Basis of this breakdown

NORTHERN WOLVES AC

Snowflake Fitout - 7 Times Square, Floors 29-31 | COP-SF-05 Bulletin 3 Revision

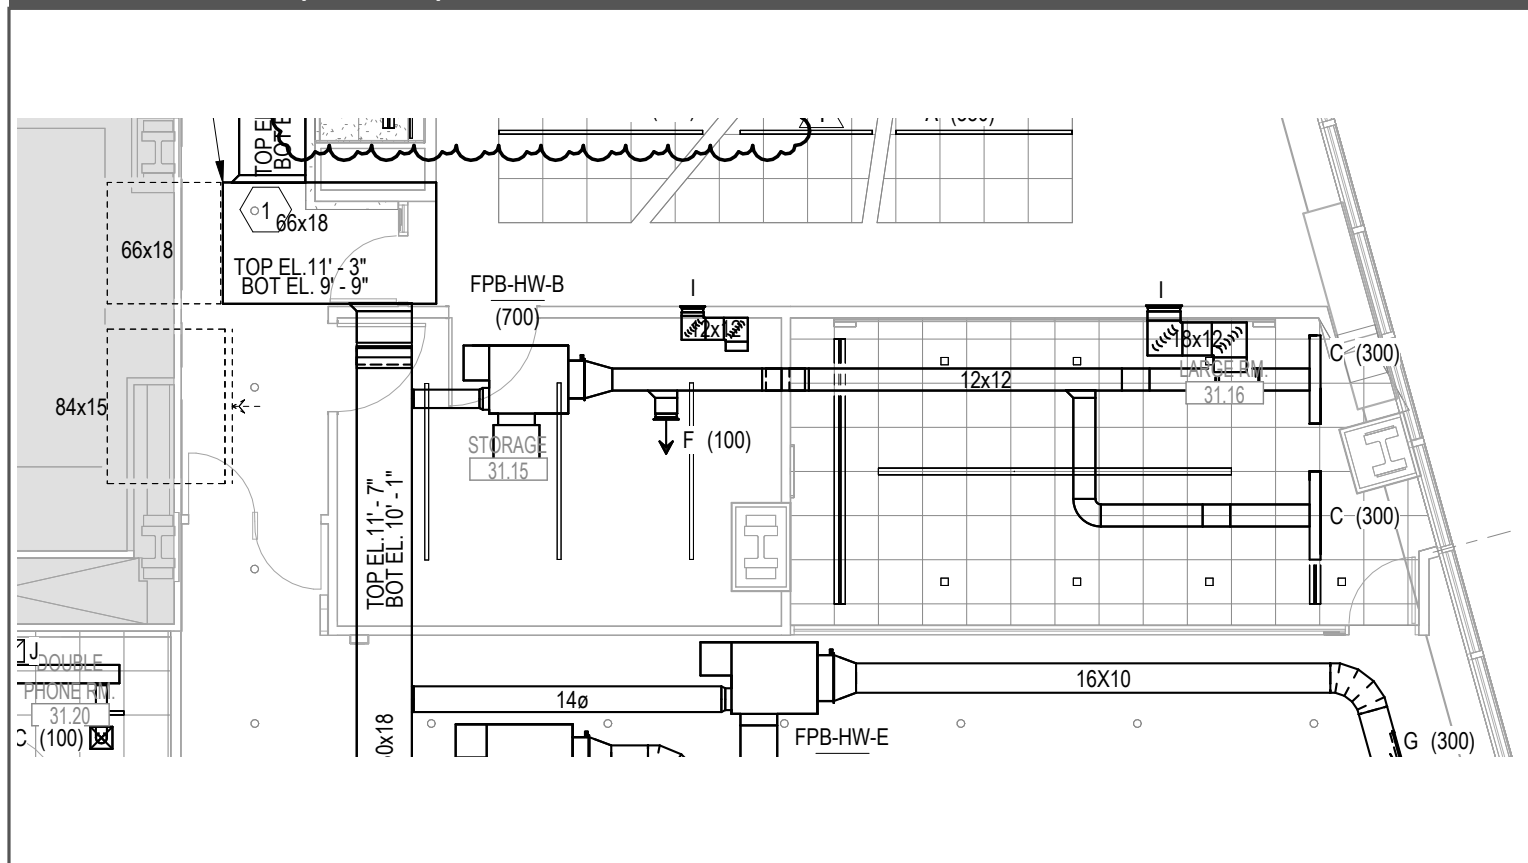
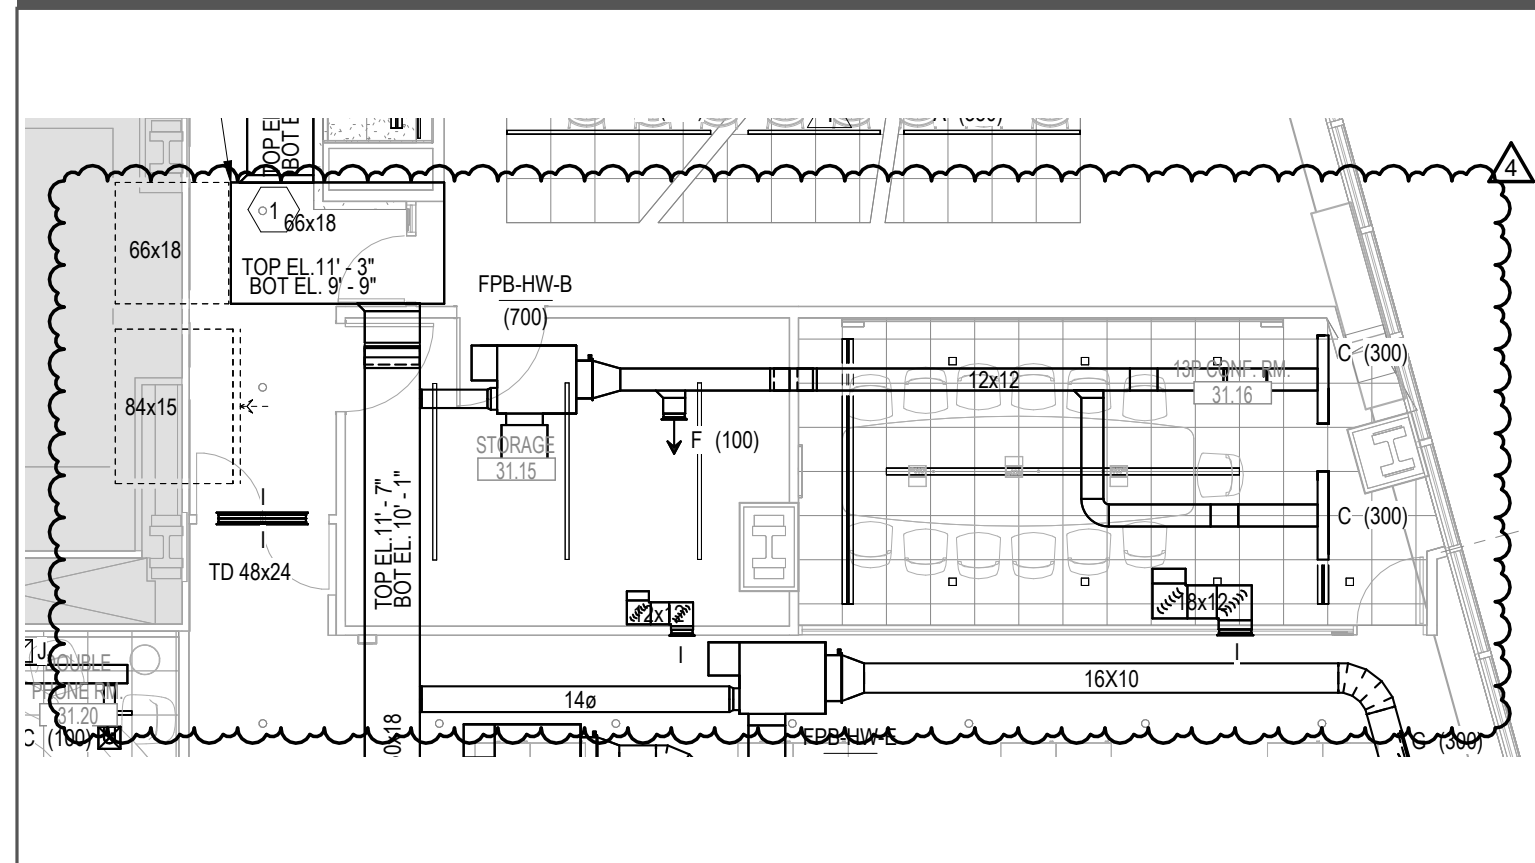
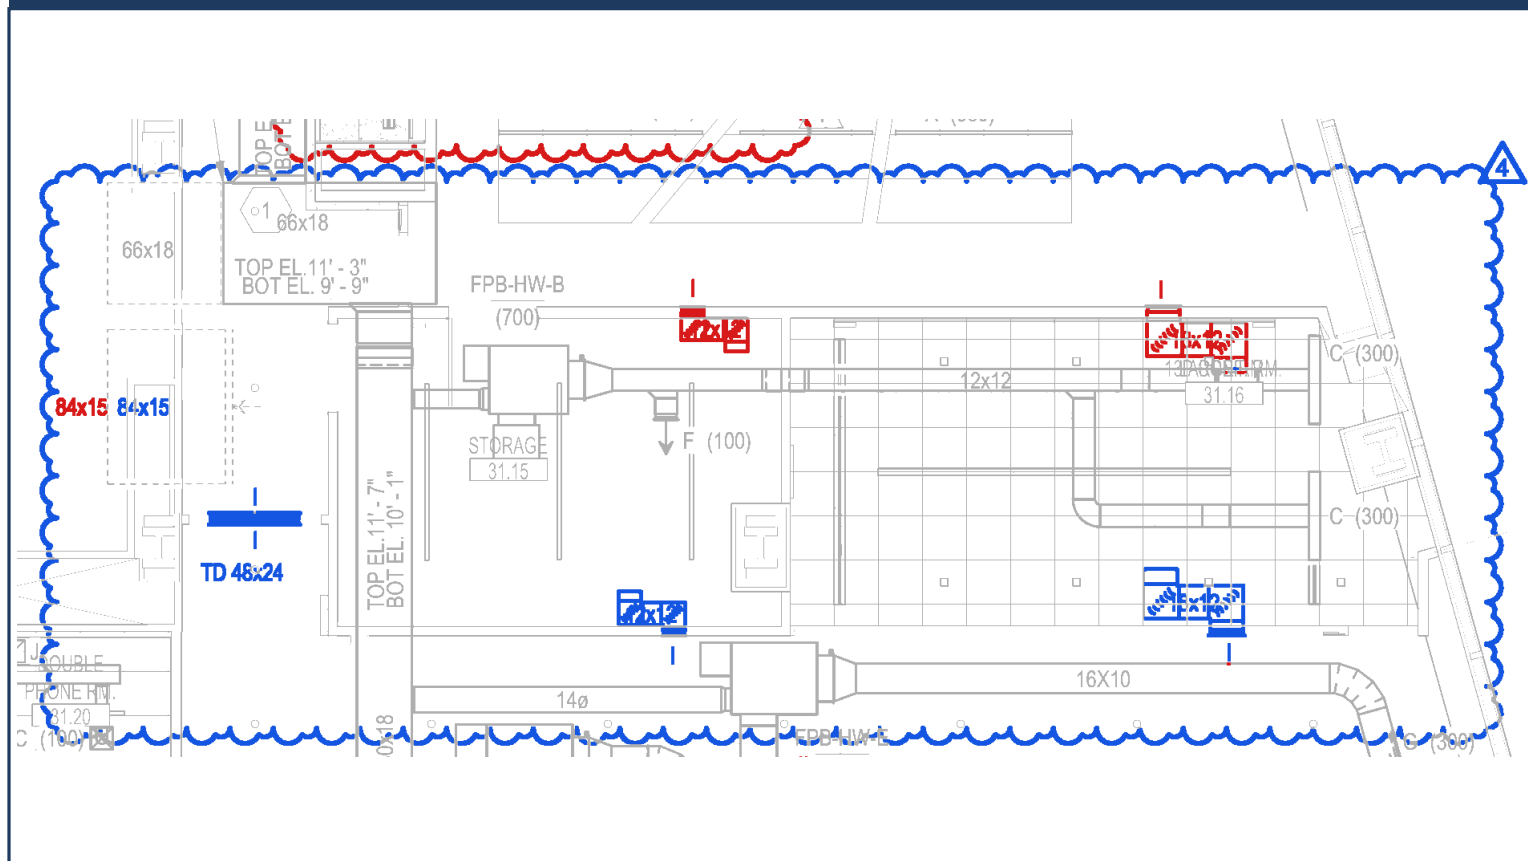
Before (Addendum 1, installed): 12x12 and 18x12 grilles at previous locations; no transfer duct at Storage 31.15.

After (Bulletin 3): New TD 48x24; 12x12 and 18x12 grilles relocated.

Work required: Remove grilles and their duct connections; fabricate and install TD 48x24, F&I 12x12 and 18x12 grilles with duct connections at new locations.
